**31 PLANE LIFTING FIXTURE**  
**# 444201**

**BELOW-THE-HOOK LIFTING DEVICE**  
**Engineering Note Cover Page**

## Calculations on IPND Segment Frame and Cart

Attached is the results of my investigation of the 31 plane lifting fixture and the IPND block assembly and shipping table lifting fixture.

Figure 1. The finite element models for Nova 31 Plane lifting fixture

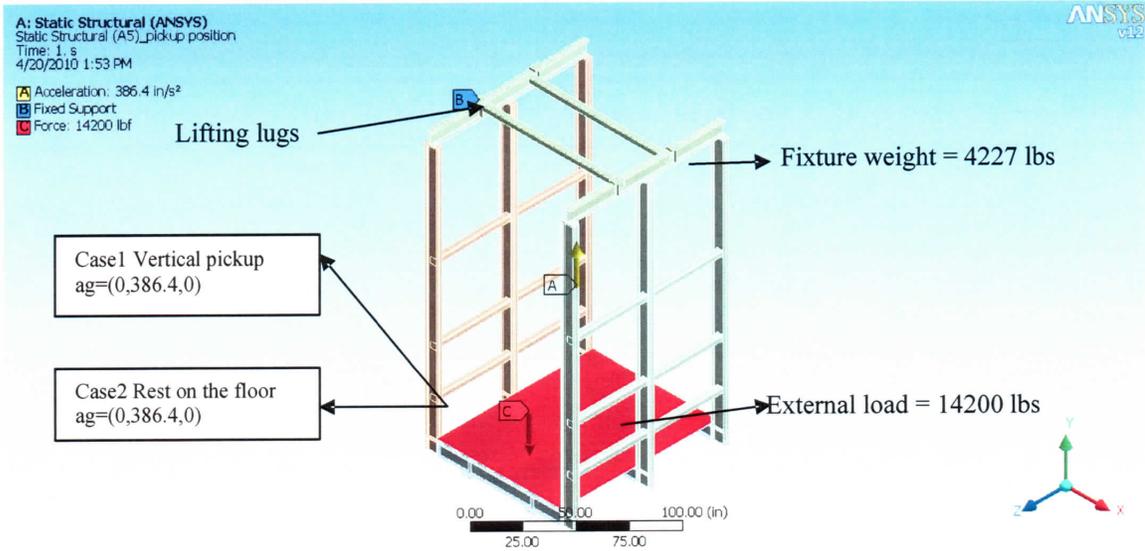
For Nova 31 plane lifting fixture, the 1/4 inch fillet welds between the 1/4 inch plate and W8x10 will have to be resized based on the AISC code requirements for weld size. The maximum size is limited to the thickness of the thinnest part to be joined which is 3/16 inch.

The finite element model for Nova 31 Plane lifting fixture is shown in Fig.1. The fixture weighs 4227 lbs and is designed either to be picked up off the floor or remain flat on the floor. The models are referred to in this report as Case1 with 14200 lbs load off the floor and Case2 with 48000 lbs load on the floor respectively. The top tubes next to the lifting lugs are checked for buckling due to the use of the lifting fixture and the sling angle. The actual required welds and bolts are sized with hand calculations covered later in this report.

3/16 inch fillet welds @ 6 places (change from 1/4 inch weld to 3/16 inch weld)

Figure 2. The finite element models for Nova IPND Block Assembly and Shipping Table lifting fixture

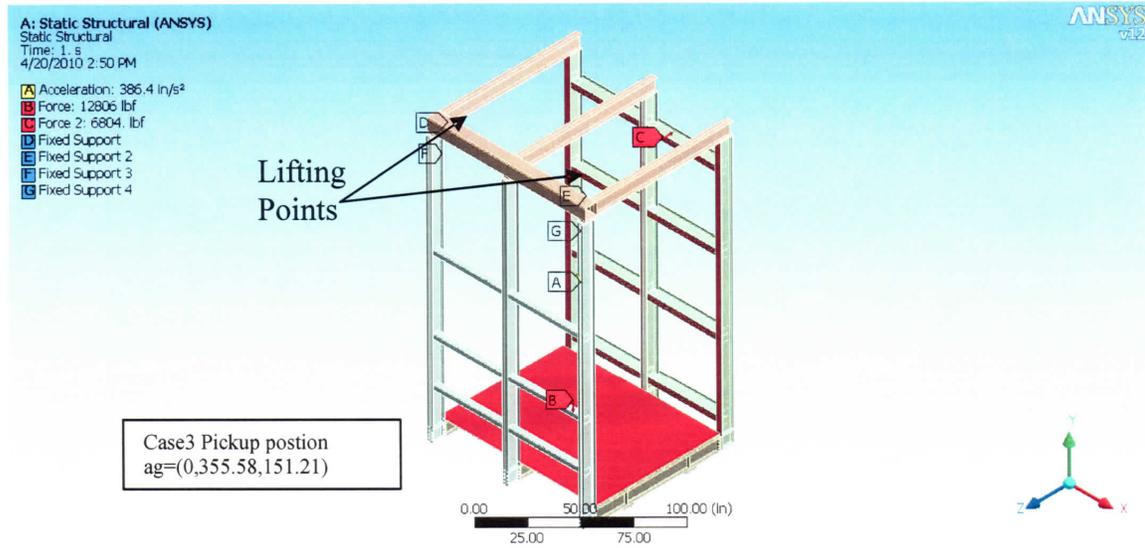
For IPND block assembly and shipping table lifting fixture, one 3/4 inch diameter grade 5 bolts will have to be upgraded to grade 8. The 5/16 inch fillet welds under the lifting point will have to be resized based on the AISC code requirements for weld size. The proper size will have to be 3/16 inch. Another 5/16 inch fillet weld at the connection of the top frame will also have to be decreased to 3/16 inch for the same reason. Since the weld size was reduced, two 1/2 inch plates will have to be added at this joint to increase the weld length.

**Figure 3. Deformation Uy in Case1**

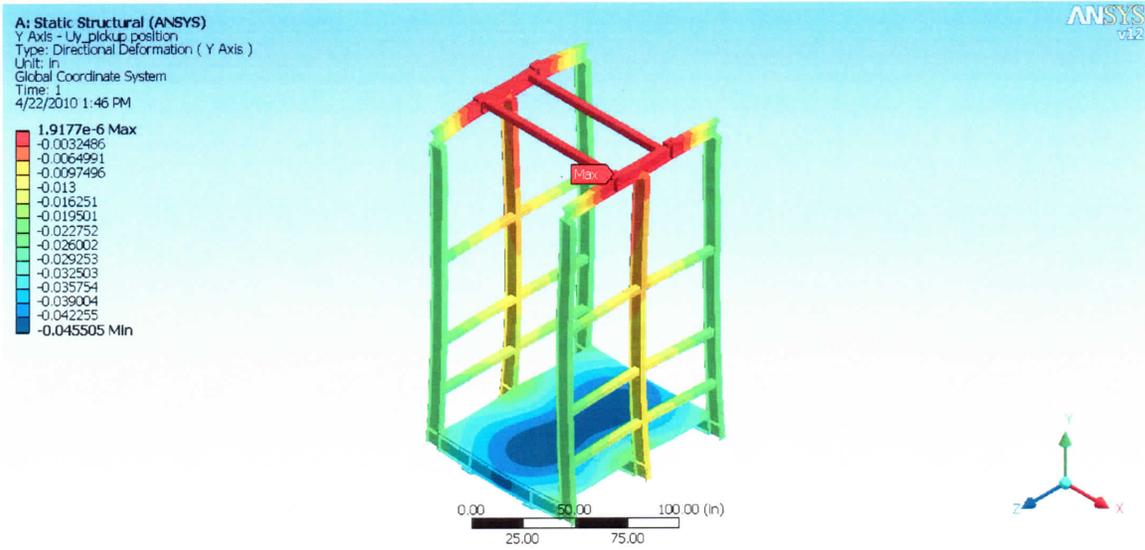
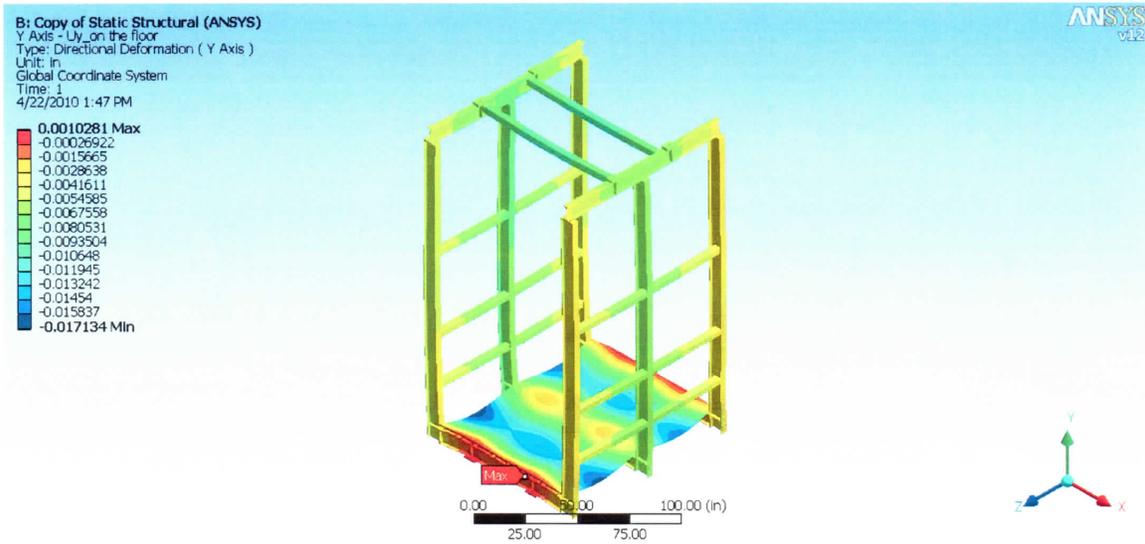
The deformed shapes of the Nova 31 Plane lifting fixture are shown in Figs.3 and 4.
